Memorandum

Subj: Mediterranean Village – Coral Gables, Florida

Responses to Outstanding Transportation/Parking Items

VALET OPERATING PLAN - LEVEL 01

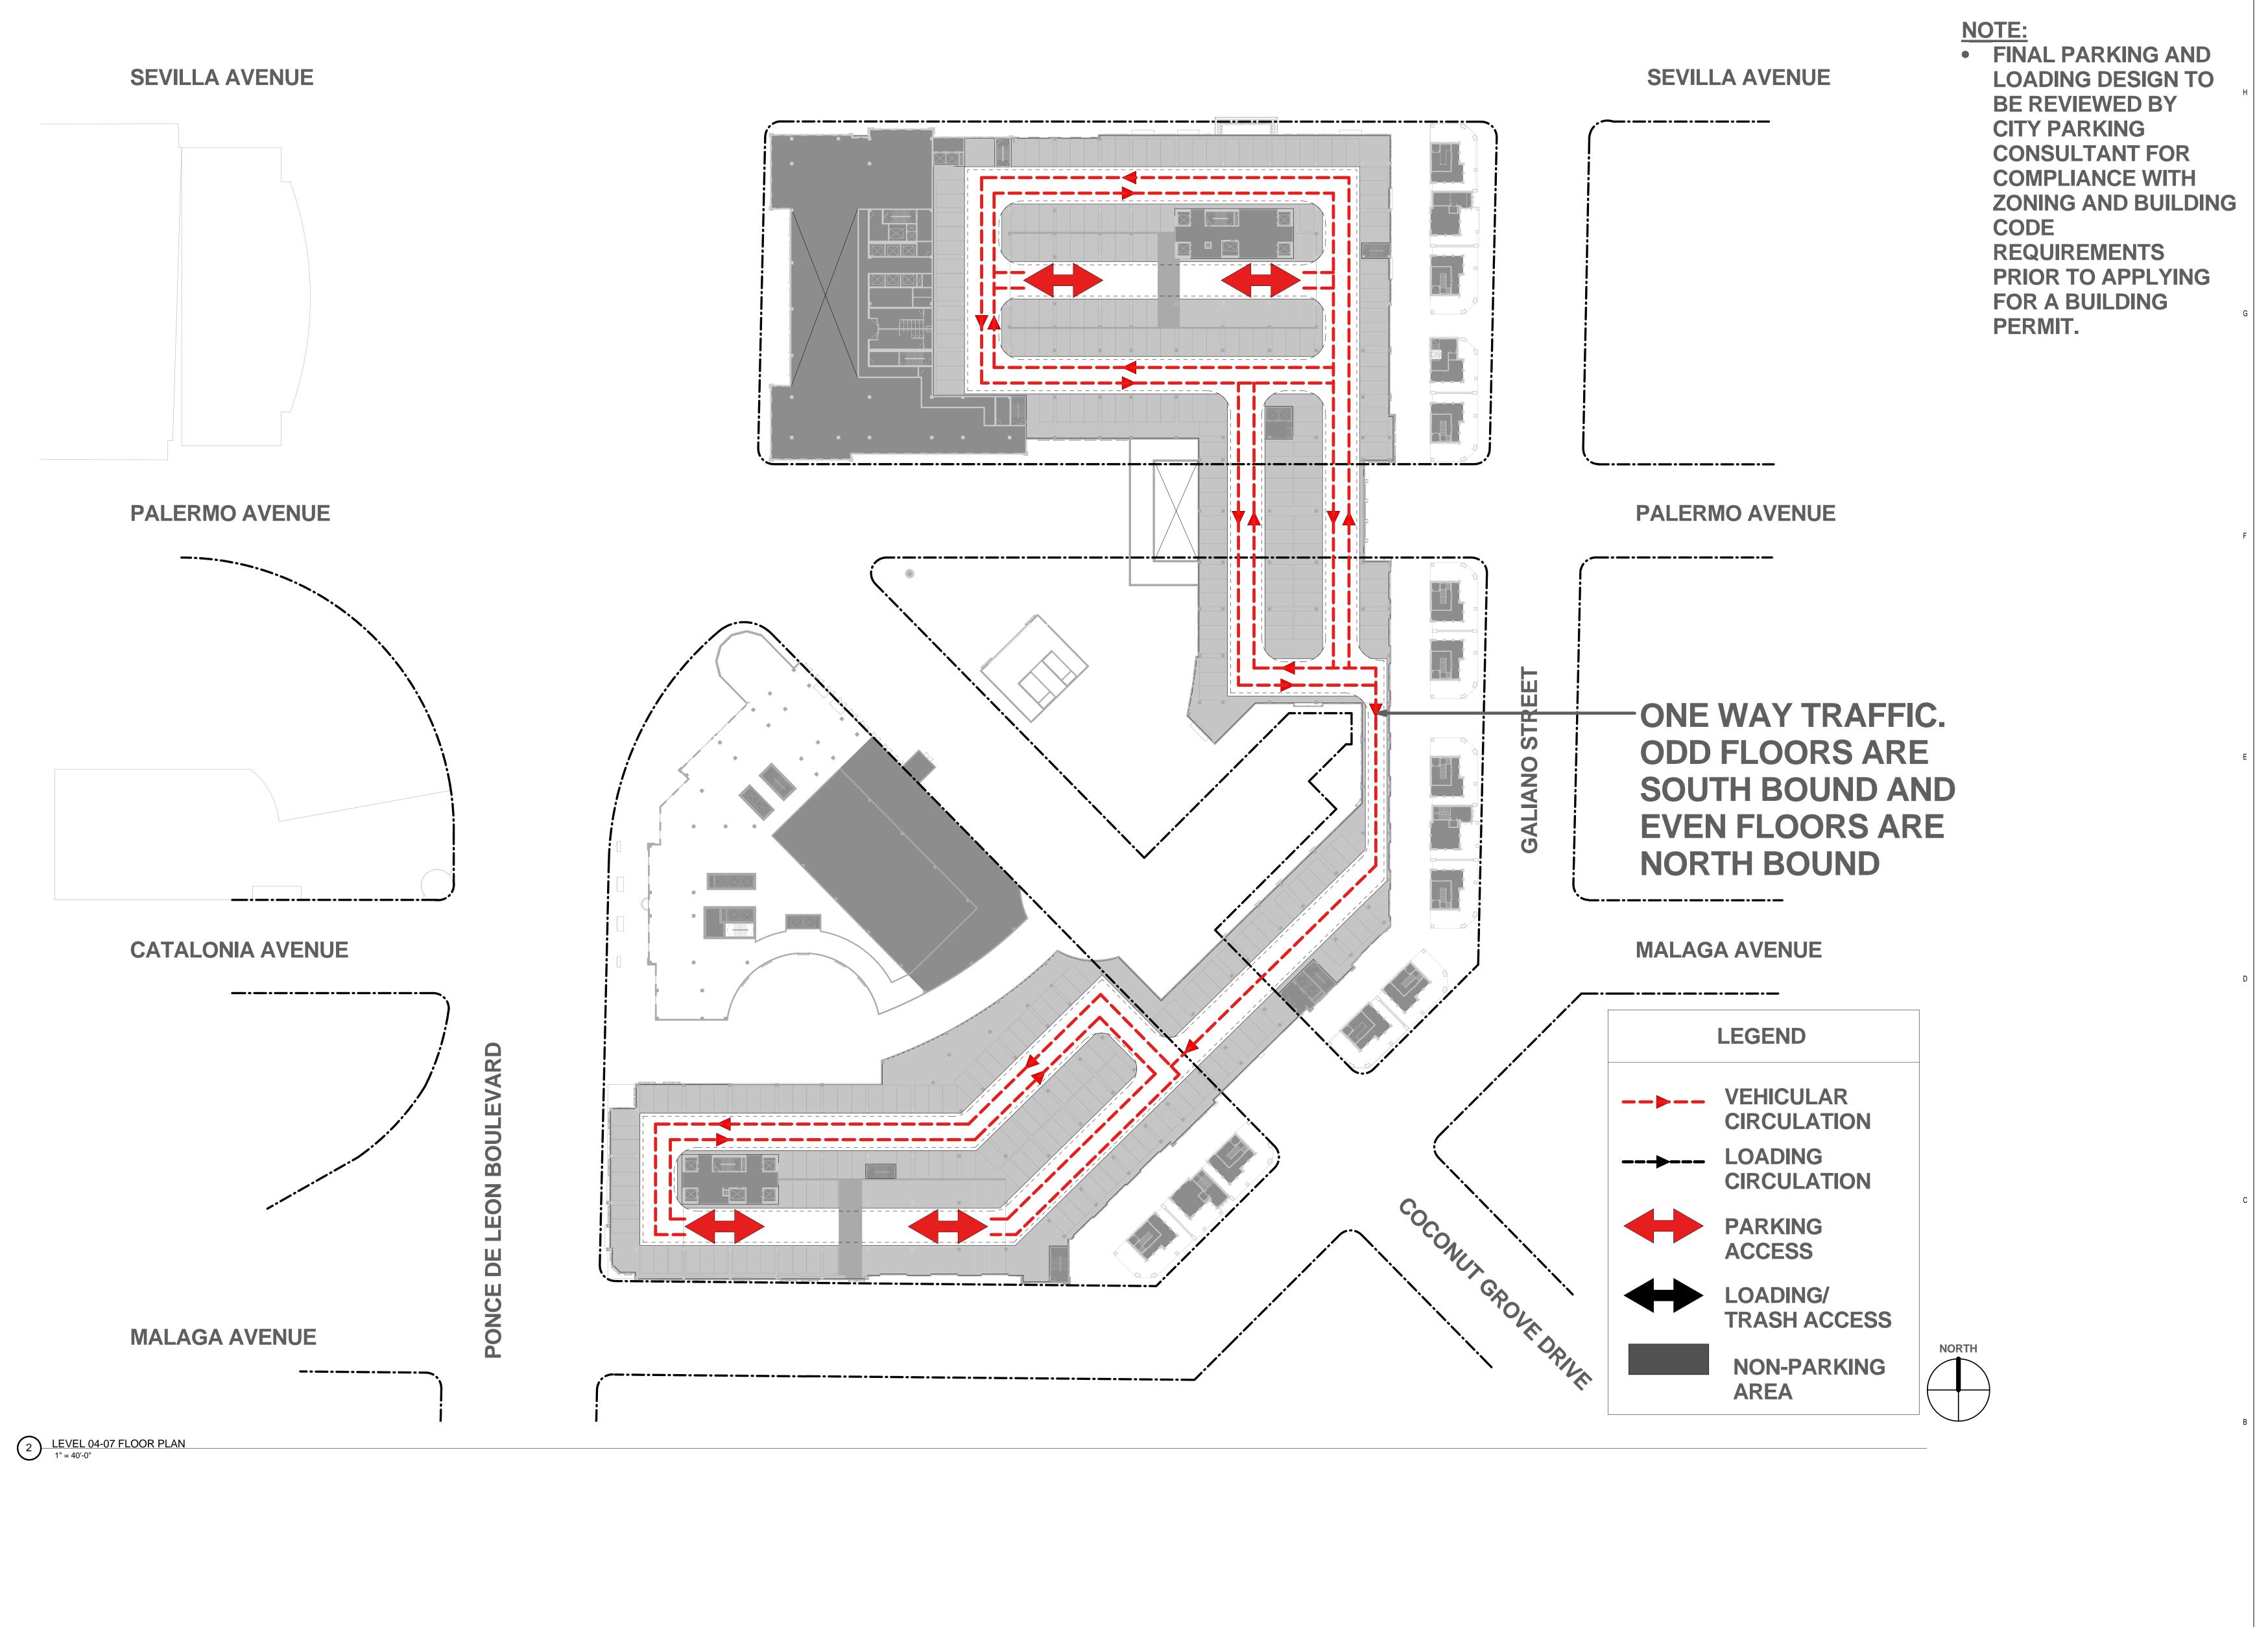
2. Eastbound Palermo Avenue Valet Station Relocation

Staff has indicated a desire to relocate the eastbound valet drop-off station along Palermo Avenue to the east away from the Arts Center. In response to this request, the valet station has been moved as far east as feasible while maintaining the same number of valet service positions. Refer to Attachment A.

VEHICULAR CIRCULATION

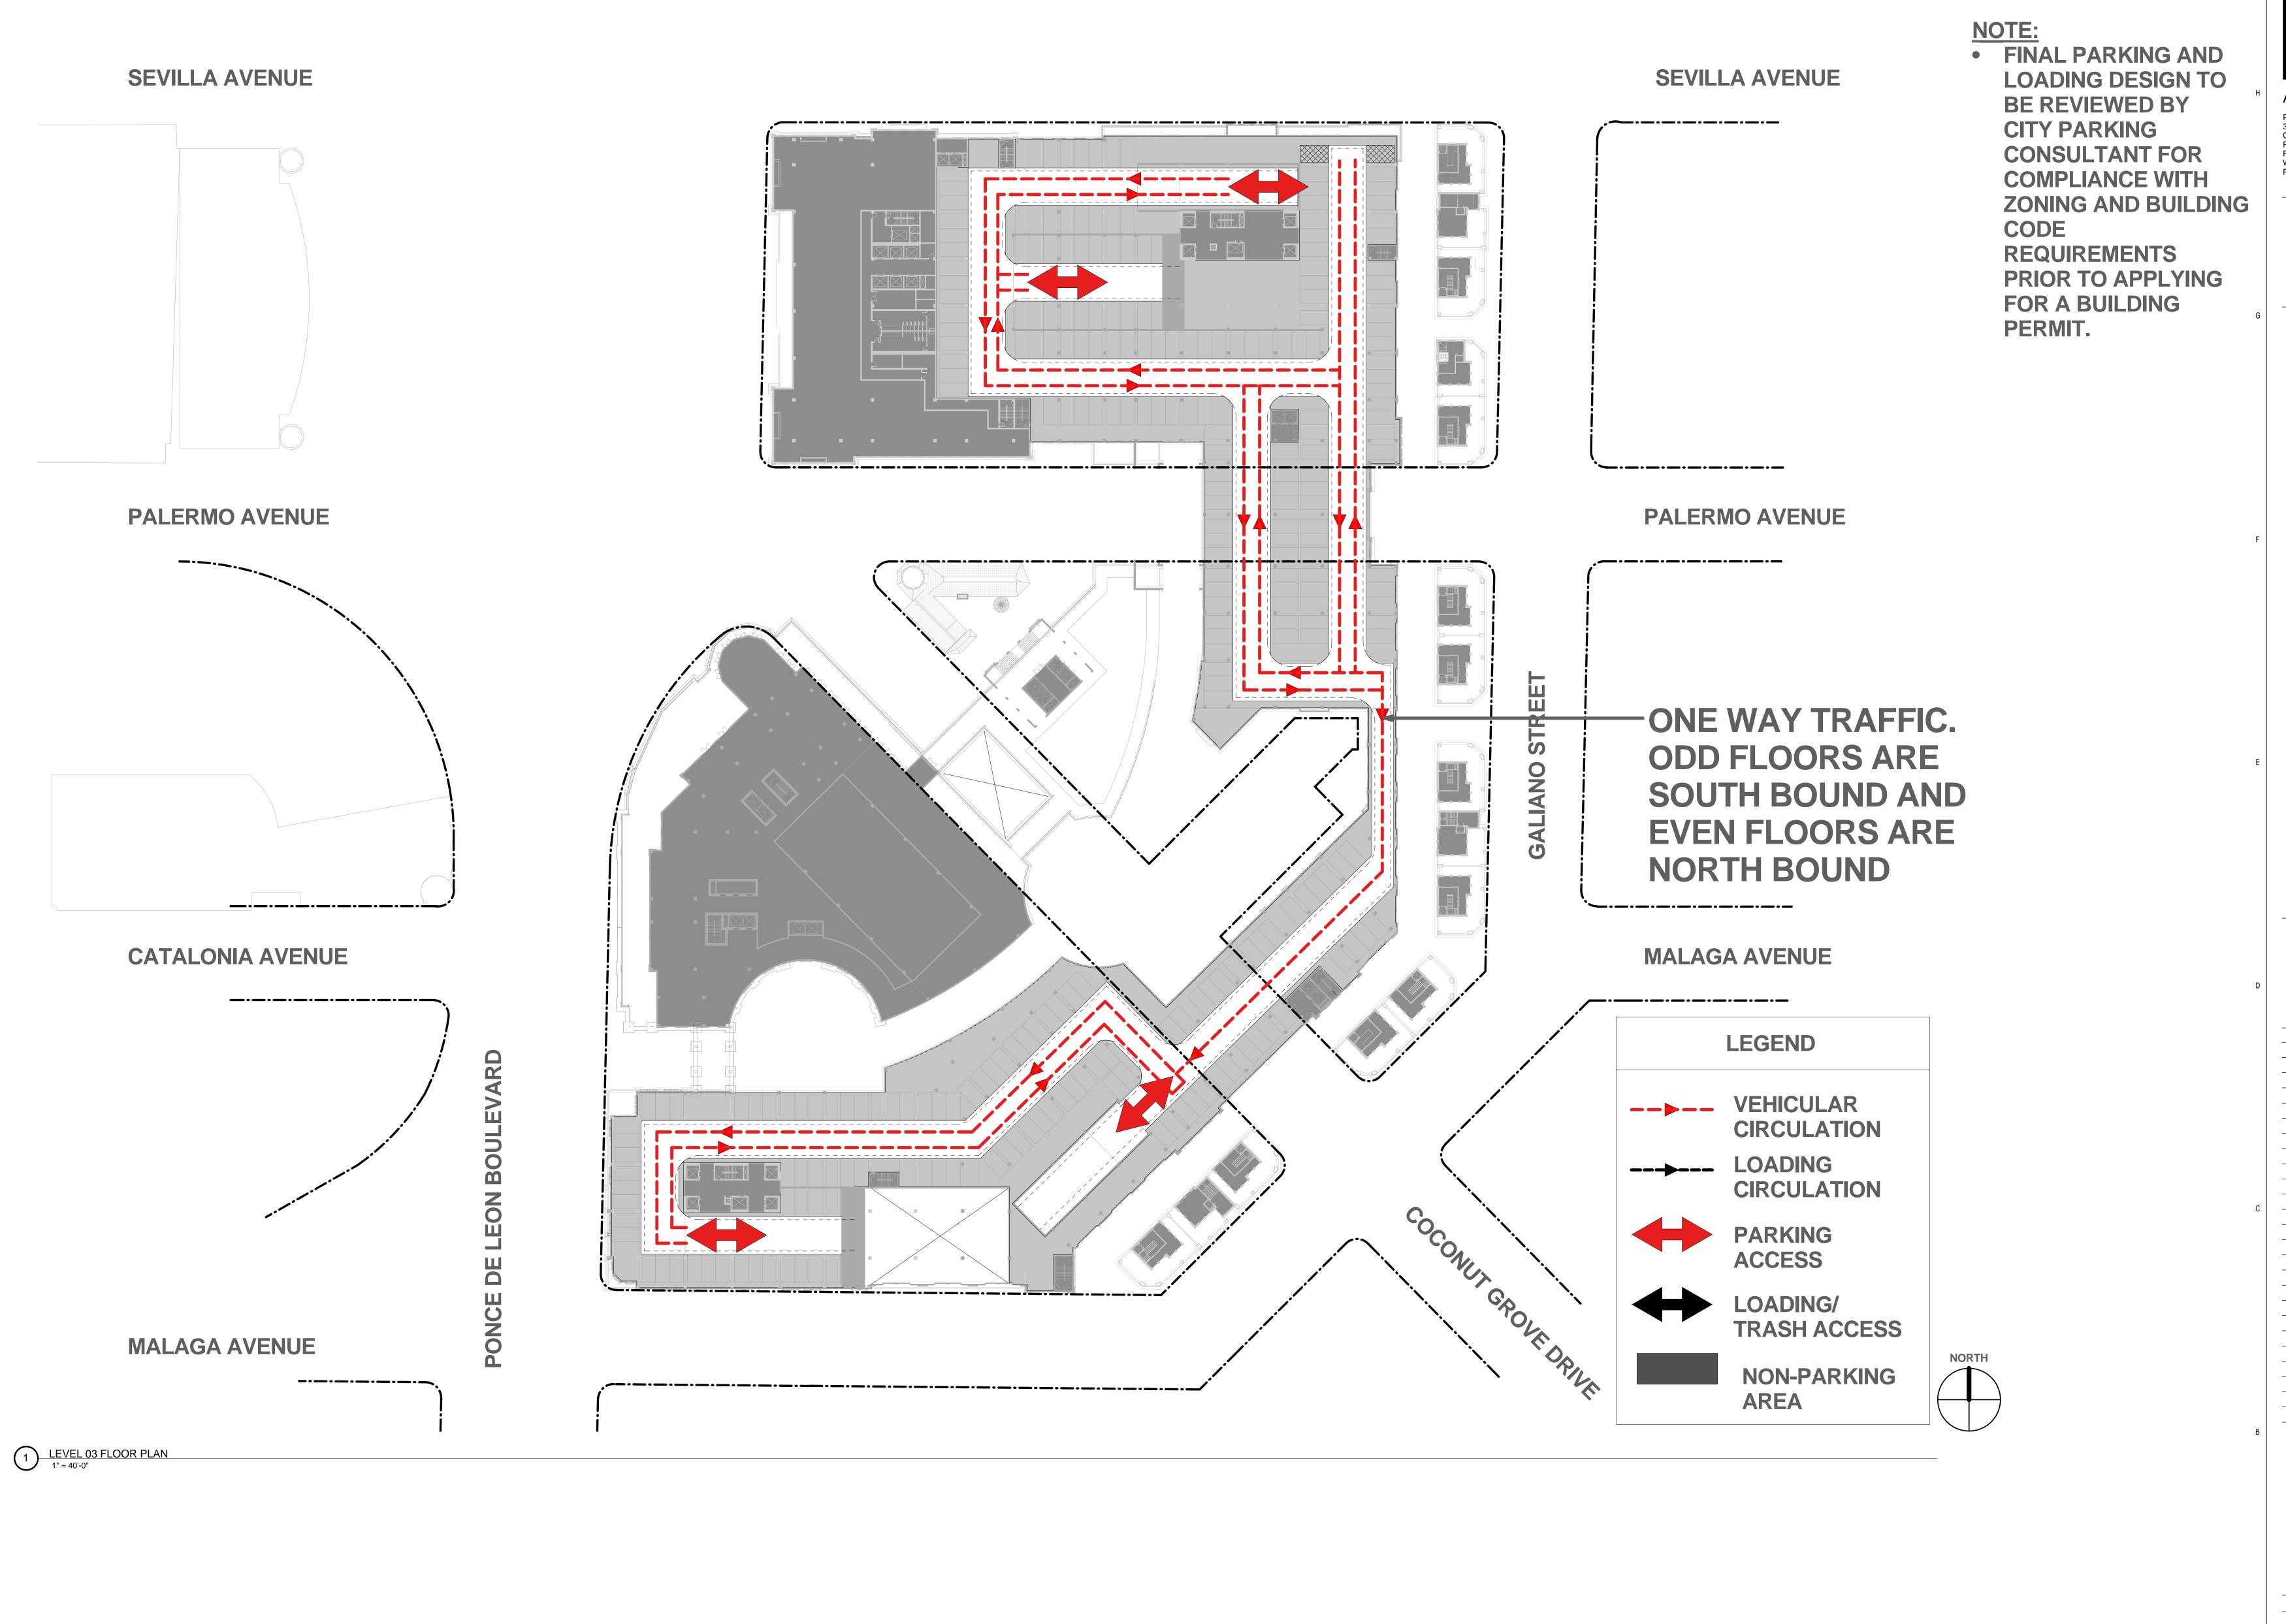
3. Parking Garage North-South Connector Bridges Traffic Flow Operations

Staff has indicated that the proposed two-way operation of the 15' wide north-south parking garage connecting bridges east of the Capote residence is not acceptable. Although two-way operation of these bridges is desirable, the revised plan proposes to operate these connectors as one-way facilities alternating the direction of flow on each floor (Floors 3-7). Wayfinding signage will be developed to direct patrons to the appropriate crossing locations for each direction of travel. Refer to Attachment B.
